PCN Tracking Number: PCN_FT_016

Product Change Notification

Product Part Number	FT120T and FT120Q	Estimated implementation date
Description of Change	Update from Rev B to Rev C to improve compatibility with D12	2013-30-04
Reason for Change	To ensure no or minimum changes needed to migrate D12 to FT120; see TN_142 for background details.	
Detailed Description	All the backward compatible issues listed below have been fixed: BUG A : Interrupt will be generated even if it is disabled BUG B : Suspend not asserted while clock_running=1 BUG C : Lazy_clk do not output when clock_running=1 and no_lazy_clk=0 BUG D : GL_N remains on when suspended BUG E : Goodlink output is not open-drain BUG F : Int_n output is not open-drain	
Impact to Data sheet	No change	
Benefit of Change	No or minimum changes needed on software or hardware when migrating from D12 to FT120	
Markings to distinguish revised from:	Device date code will be changed to a "C" to indicate revision C

TN_142 FT120 Errata Technical Note

FT120 is available in a RoHS Compliant RoHS Compliant package, 28 pin QFN and 28 pin TSSOP. An example of the markings on the package is shown in Figure 1 and Figure 2.

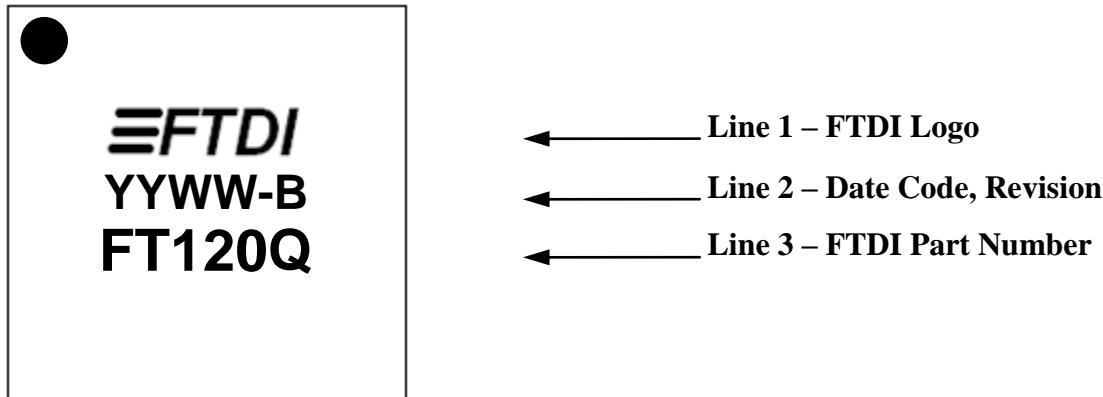
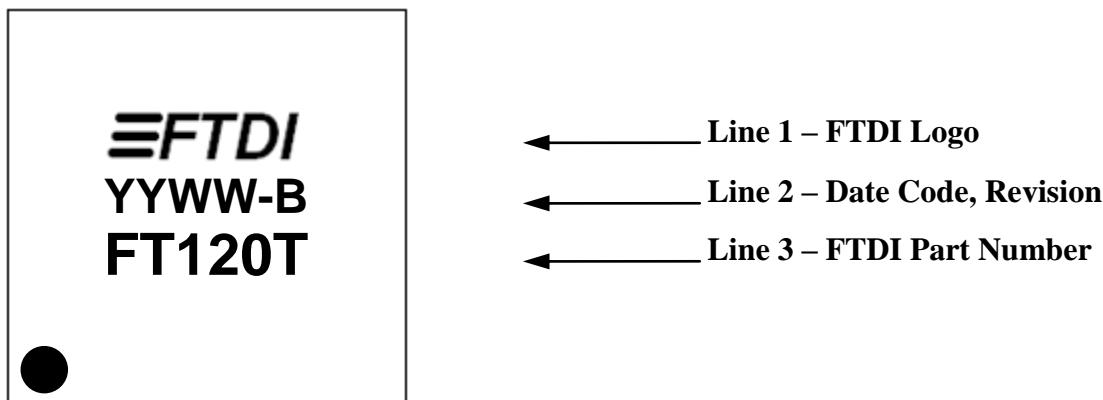
The date code format is **YYWW** where WW = 2 digit week number, YY = 2 digit year number. This is followed by the revision number.
